RAMP REPORT REGION 2 ADA 2026

Lawerence St., & Ingraham Lane,
Rockland

CR09037

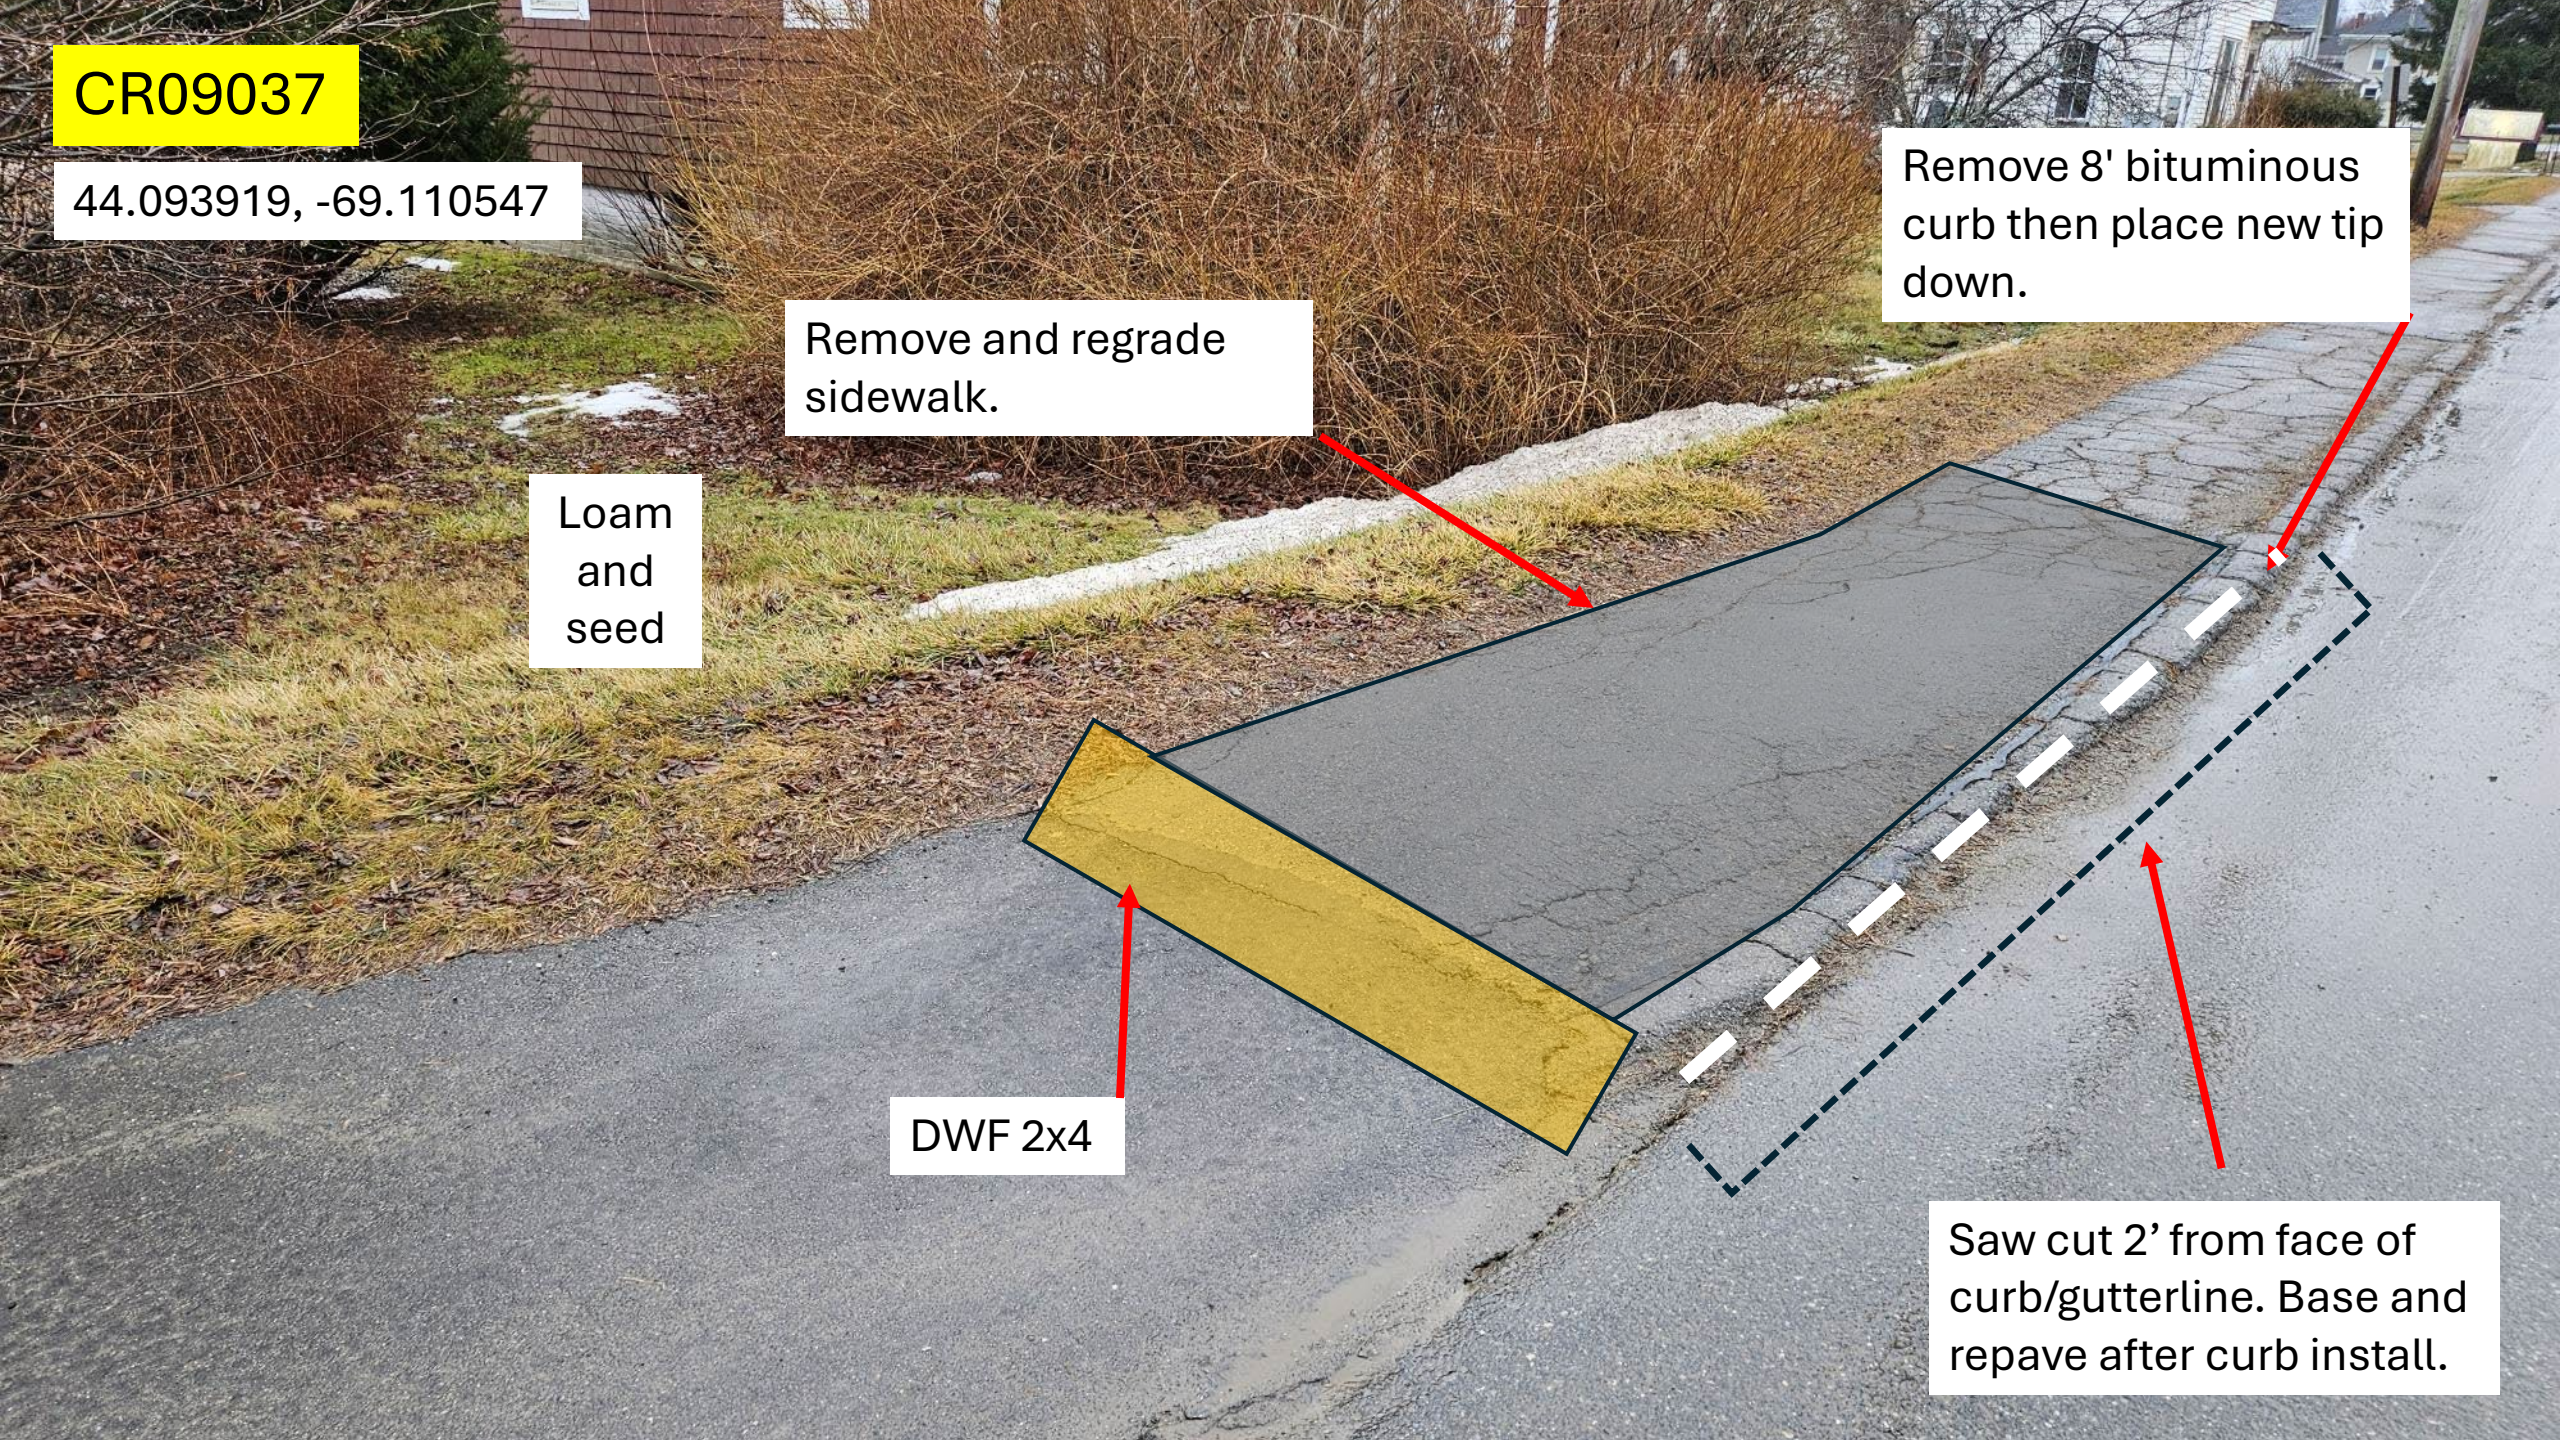
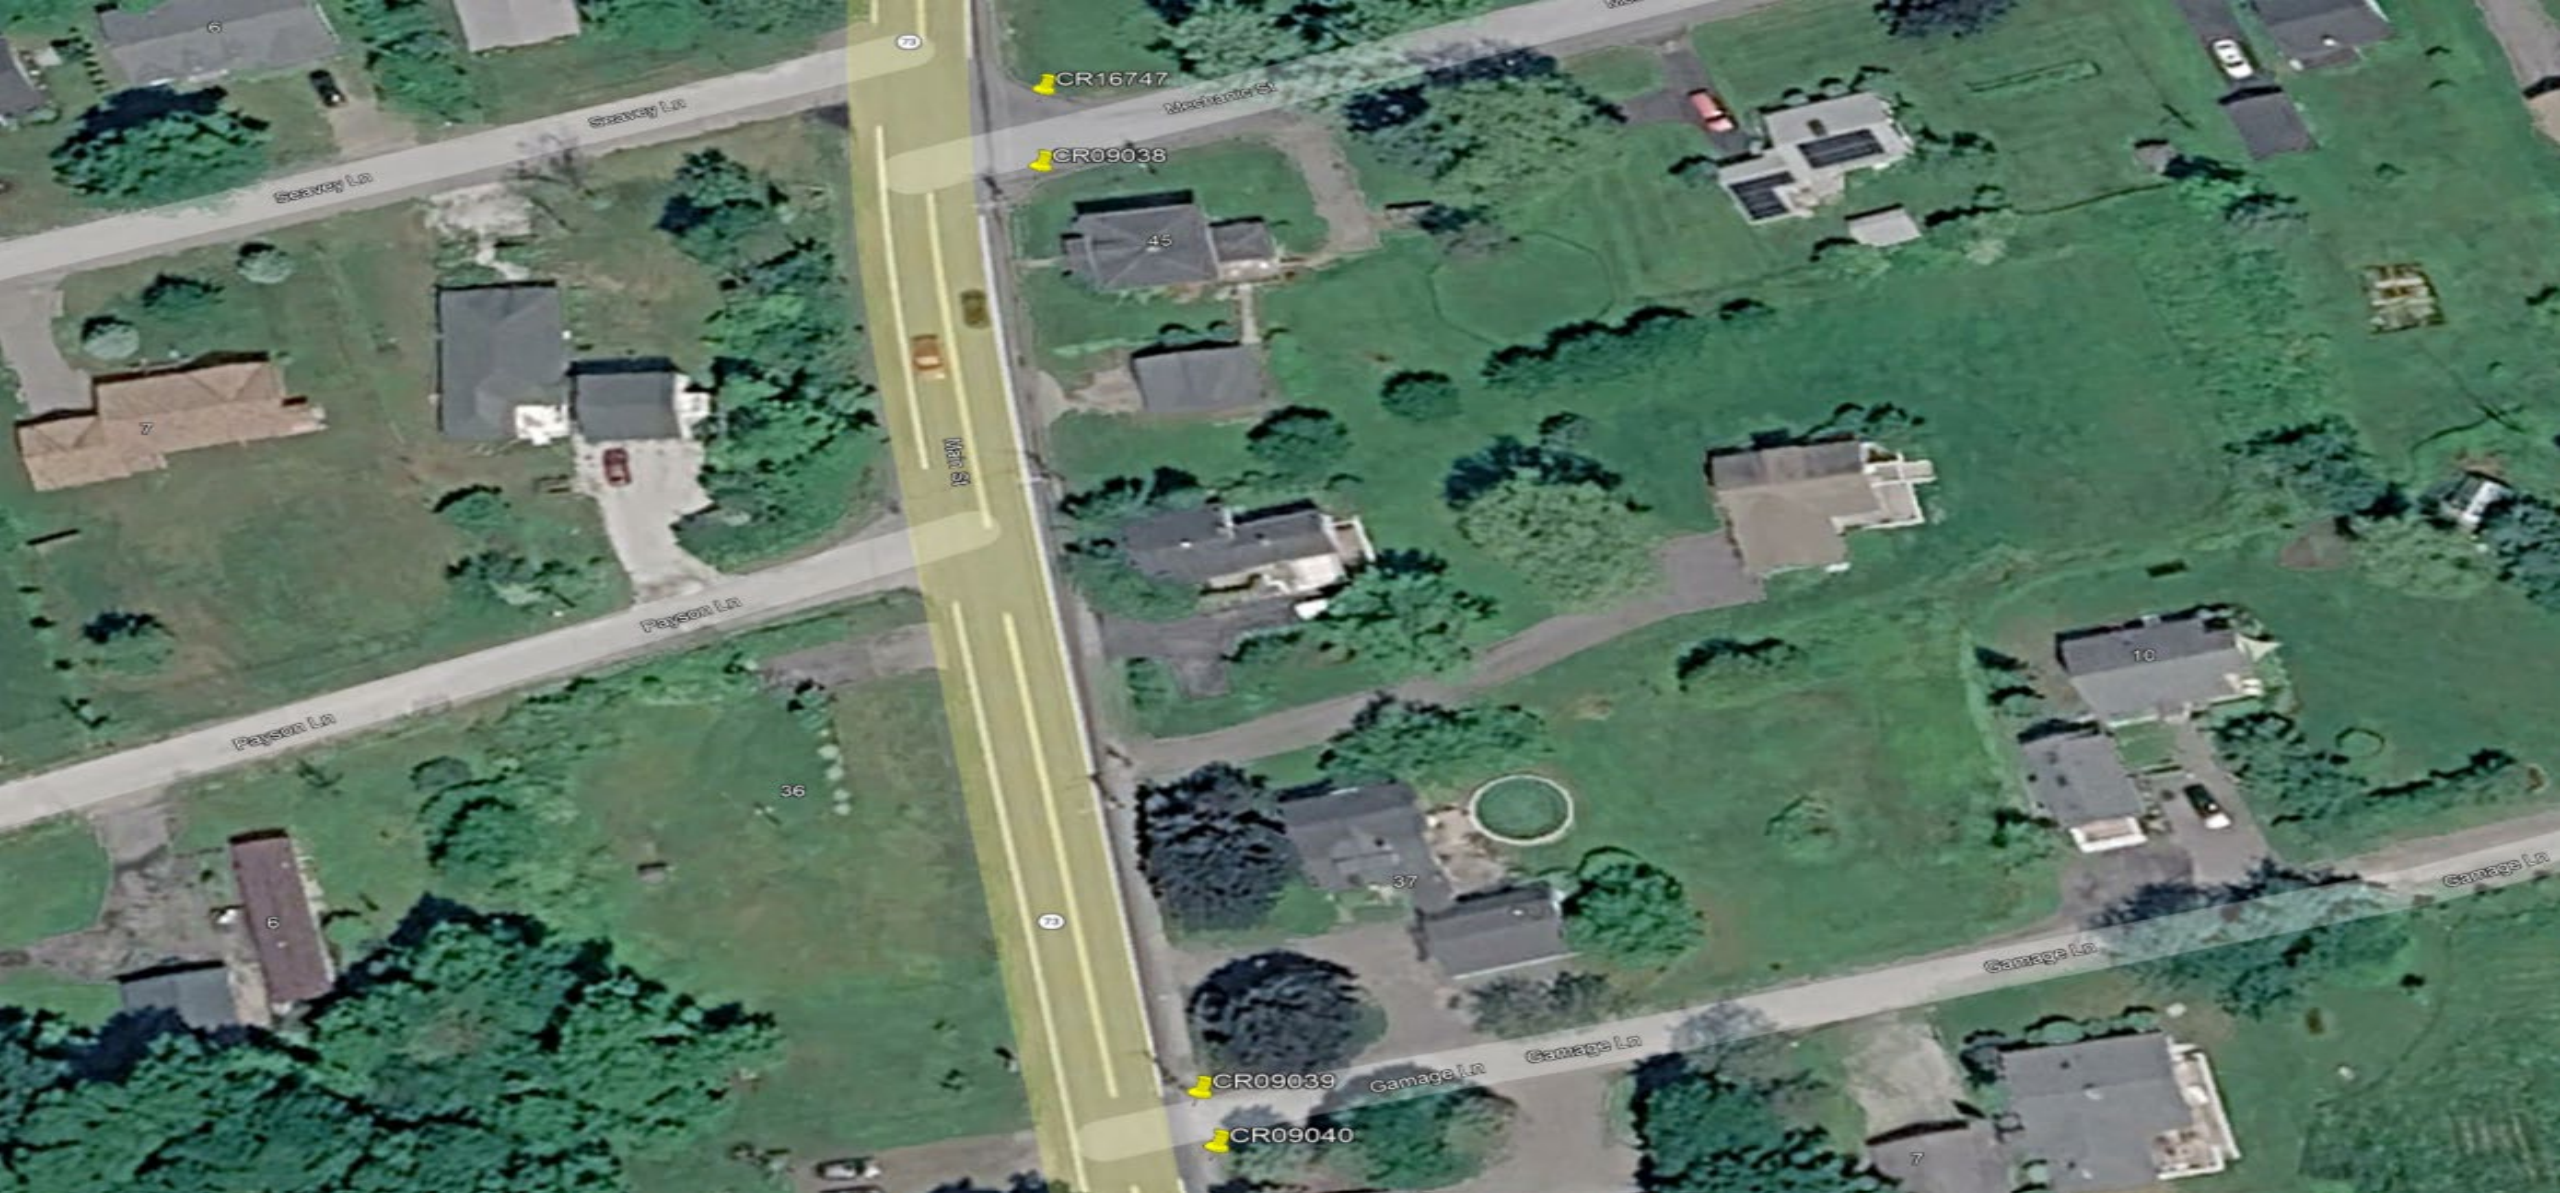
Remove and regrade
sidewalk.

Loam
and
seed

Remove 8' bituminous
curb then place new tip
down.

DWF 2x4

Saw cut 2' from face of
curb/gutterline. Base and
repave after curb install.

CR16747

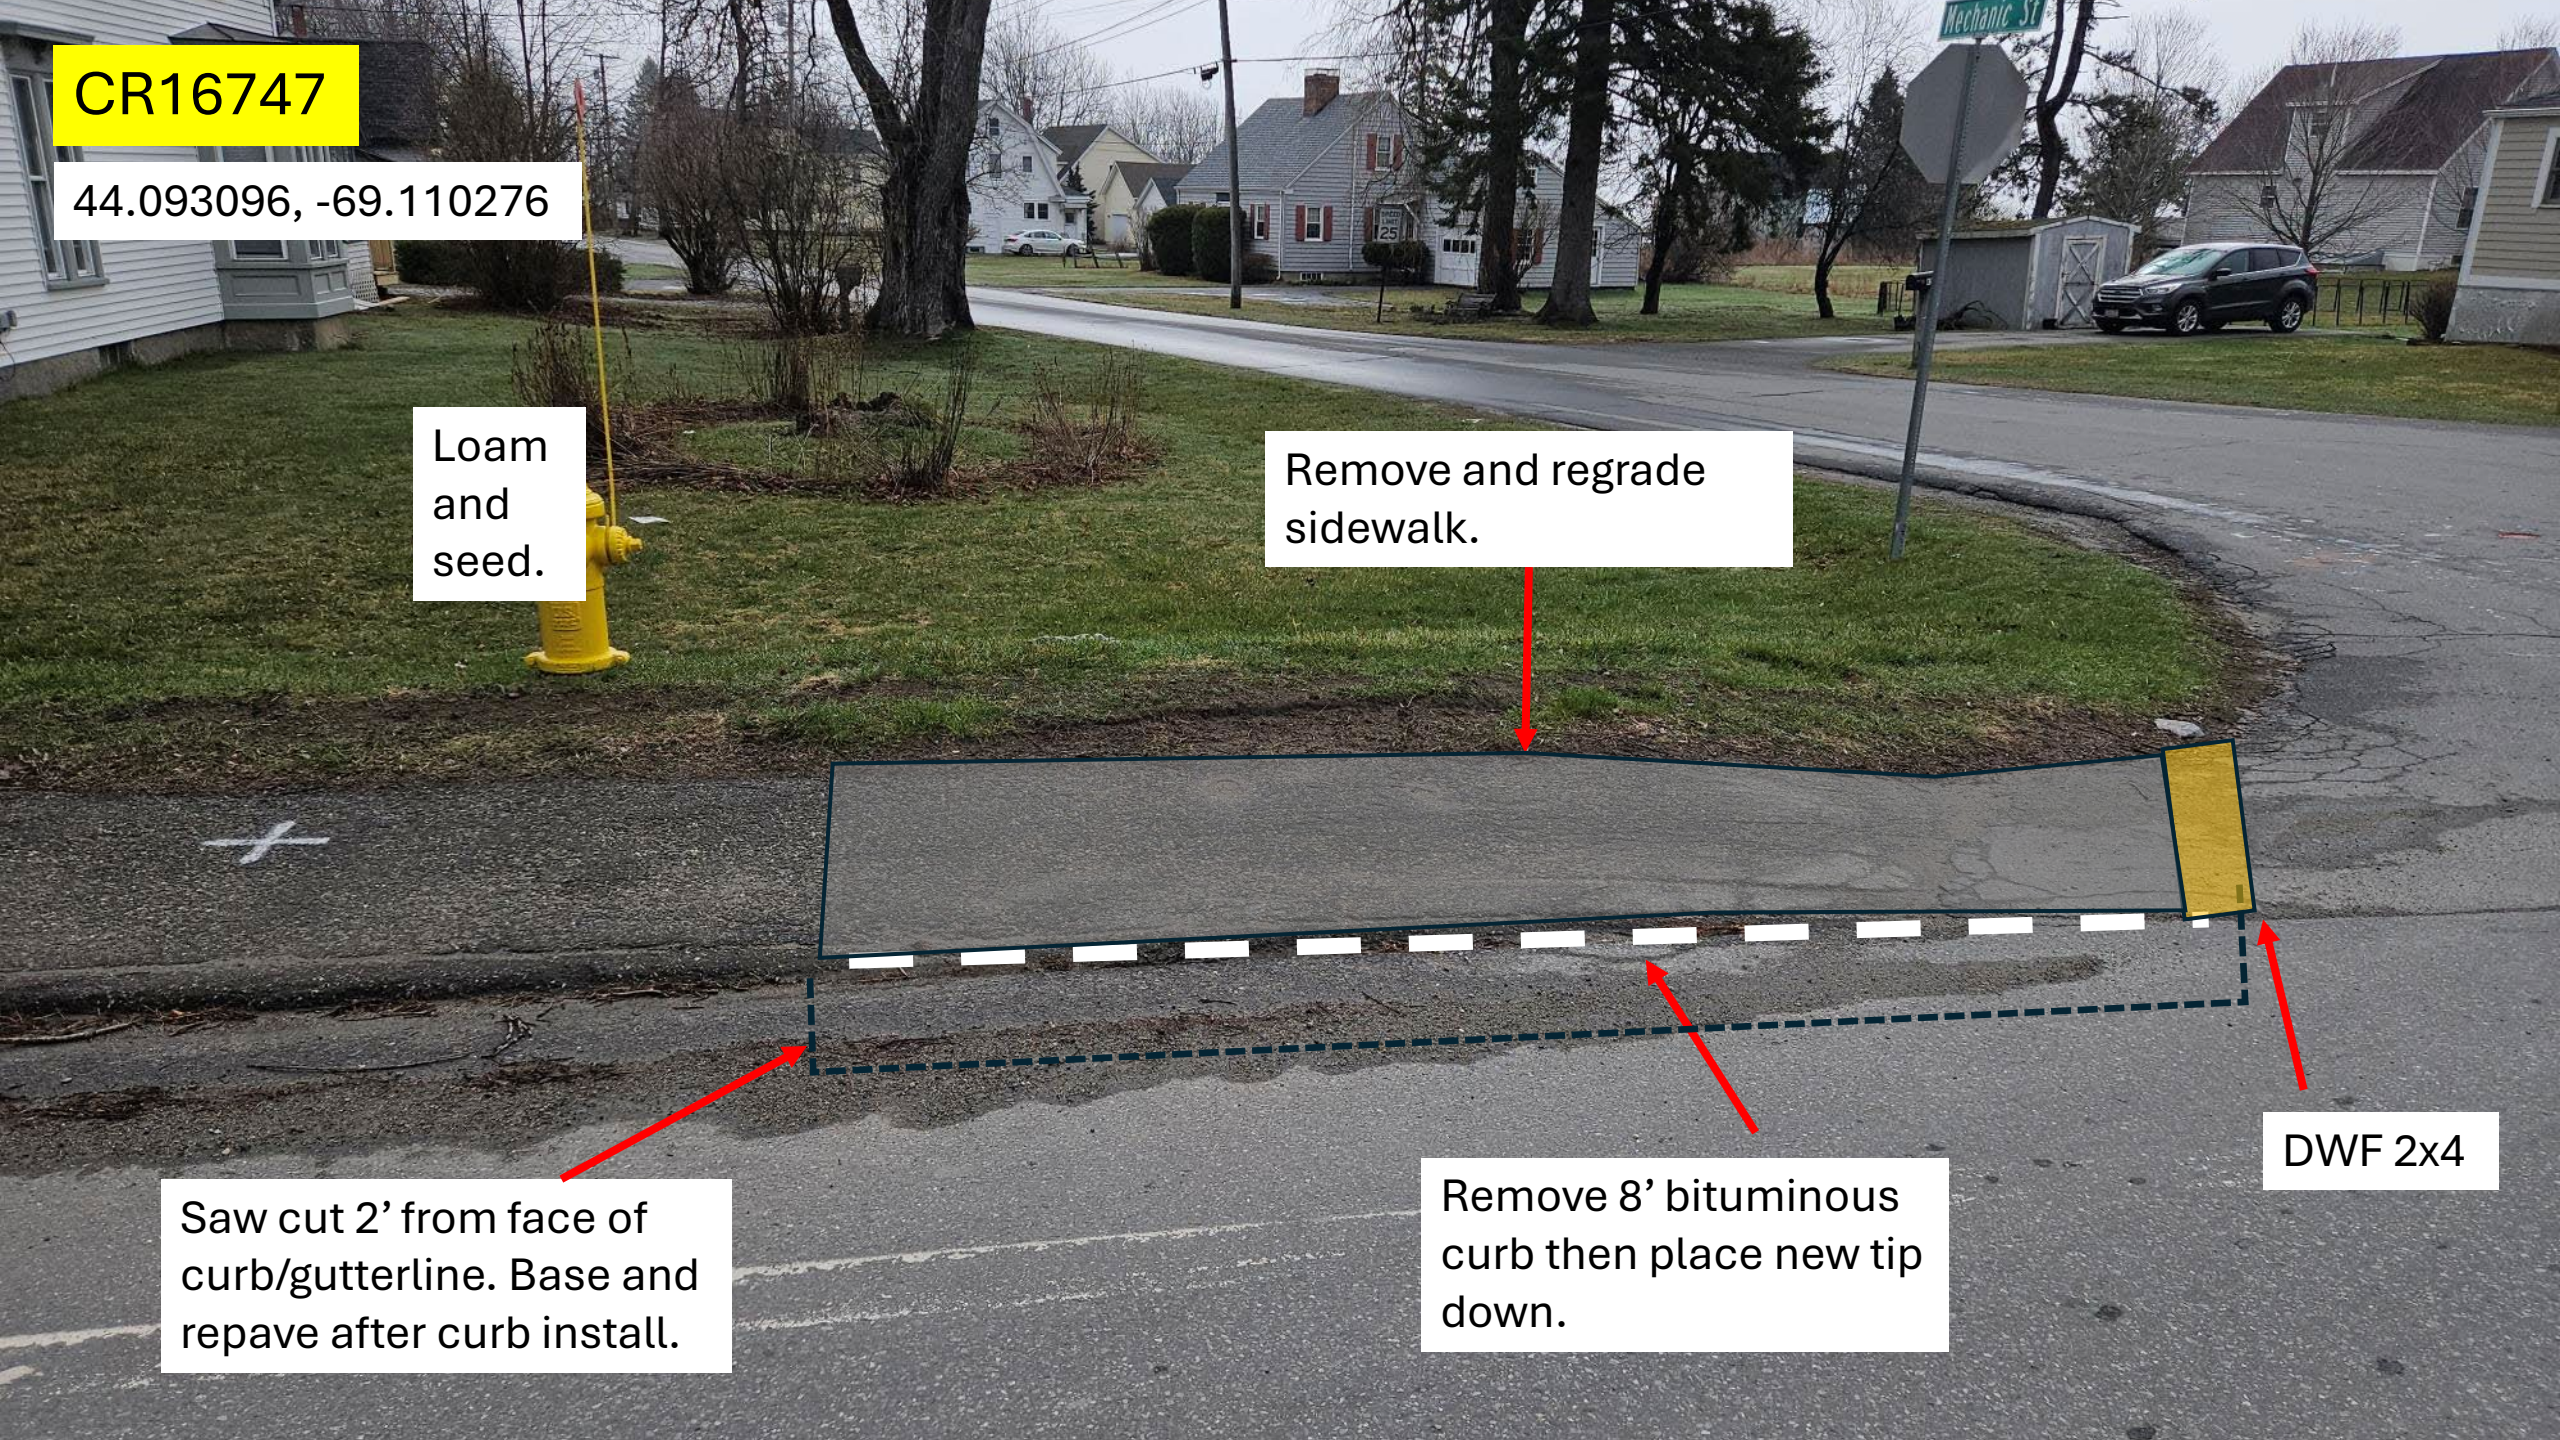
Loam
and
seed.

Remove and regrade
sidewalk.

Saw cut 2' from face of
curb/gutterline. Base and
repave after curb install.

Remove 8' bituminous
curb then place new tip
down.

DWF 2x4
